33 OVERLOOK

December 29, 1994

Re: Septic System Repair at 33 Overlook Drive
Bruce & Sally MacDougall

SYSTEM PROFILE - SECTION PARALLEL TO FLOW
(NOT TO SCALE)

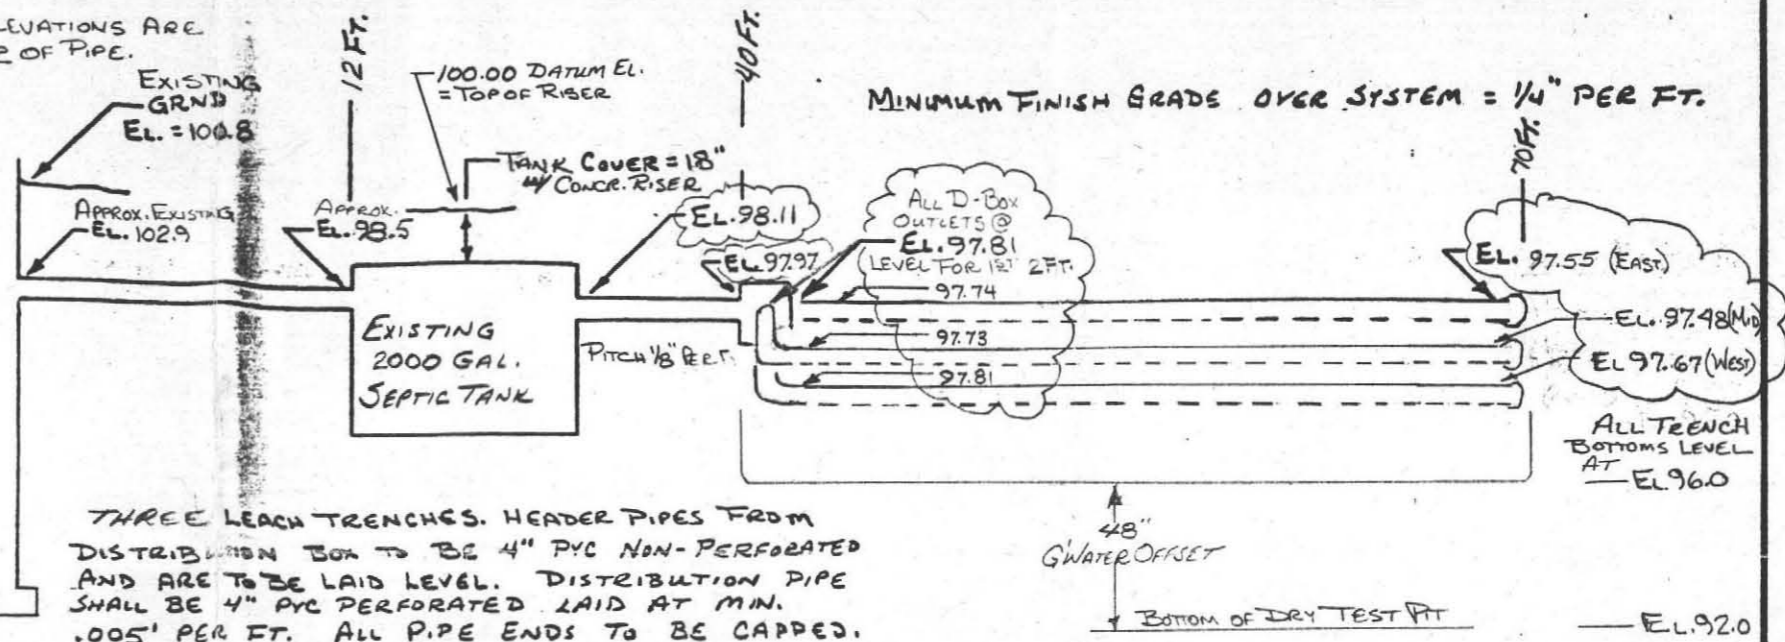
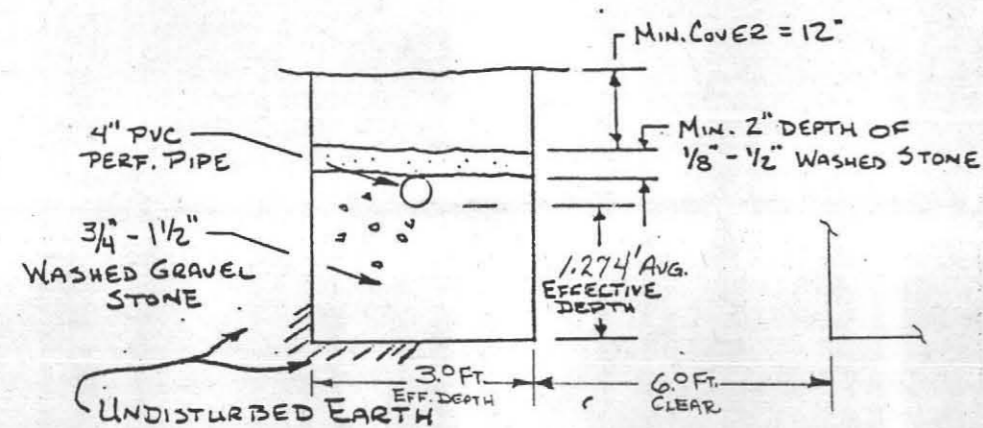
* AVERAGE EFFECTIVE TRENCH DEPTH (AS-BUILT)
= 1.27 FT AVG FOR EAST TRENCH X 33 FEET LONG
+ 1.23 FT AVG FOR MID TRENCH X 43 FEET LONG
+ 1.36 FT AVG FOR WEST TRENCH X 24 FEET LONG
÷ 100 FEET TOTAL = 1.274 FT. DEPTH

AS-BUILT ELEVATIONS IN "CLOUDS"
RMS 12-29-94

SEPTIC SYSTEM DESIGN
 AT 33 OVERLOOK DRIVE AMHERST

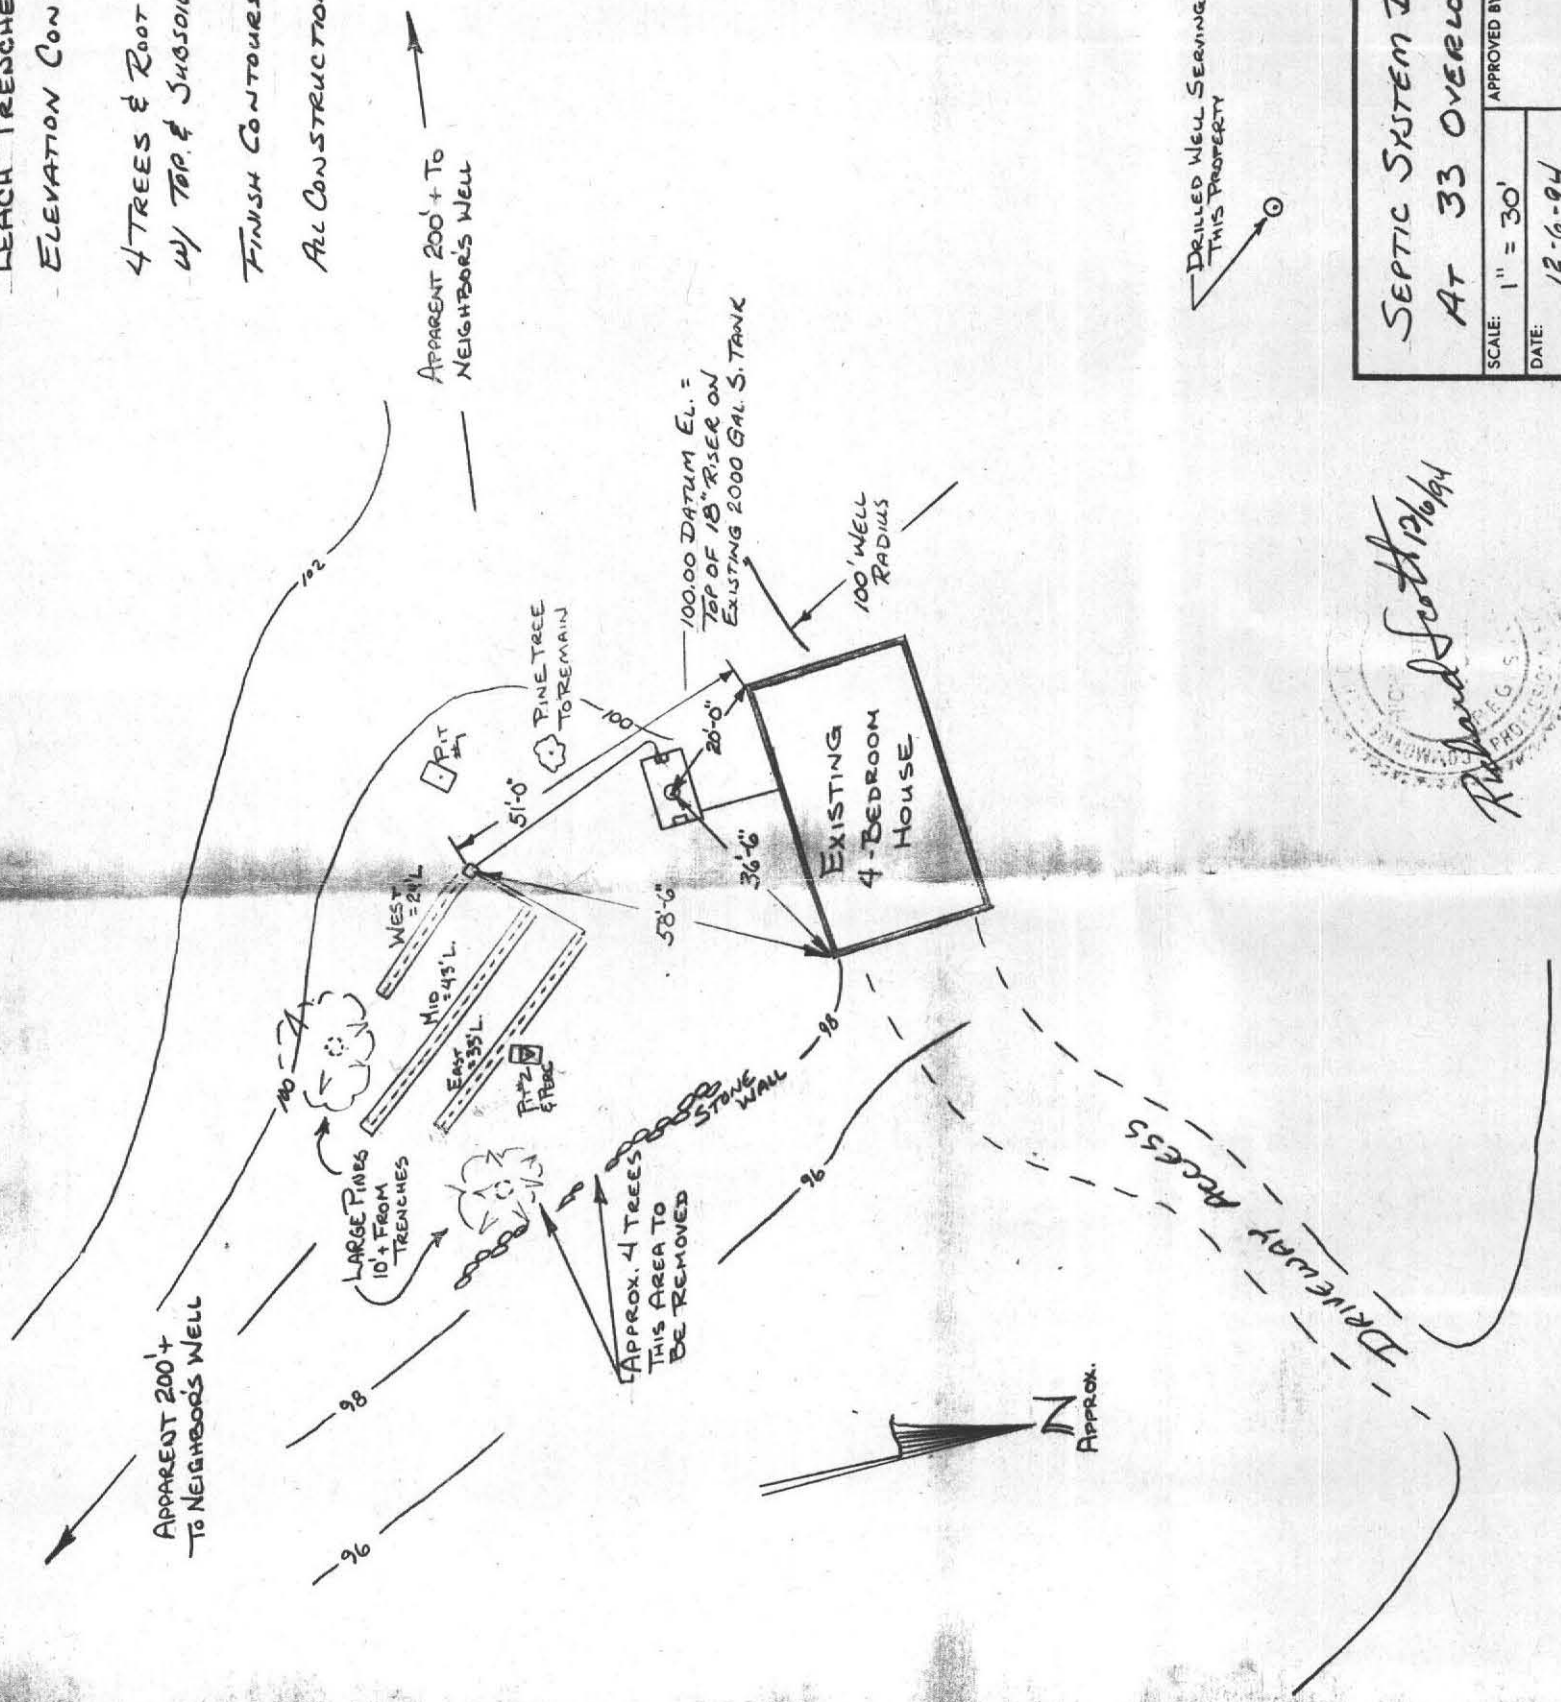
All system components are installed. In plan view the leach trenches are shifted a small amount to preserve landscape trees. This small shift will not affect system performance and the field location remains over the test pits.

SCALE: 1" = 30'
 DATE: 12-6-94
 DRAWN BY: RMS
 REVISED TO INCLUDE AS-BUILT CONDITIONS RMS 12-27-94
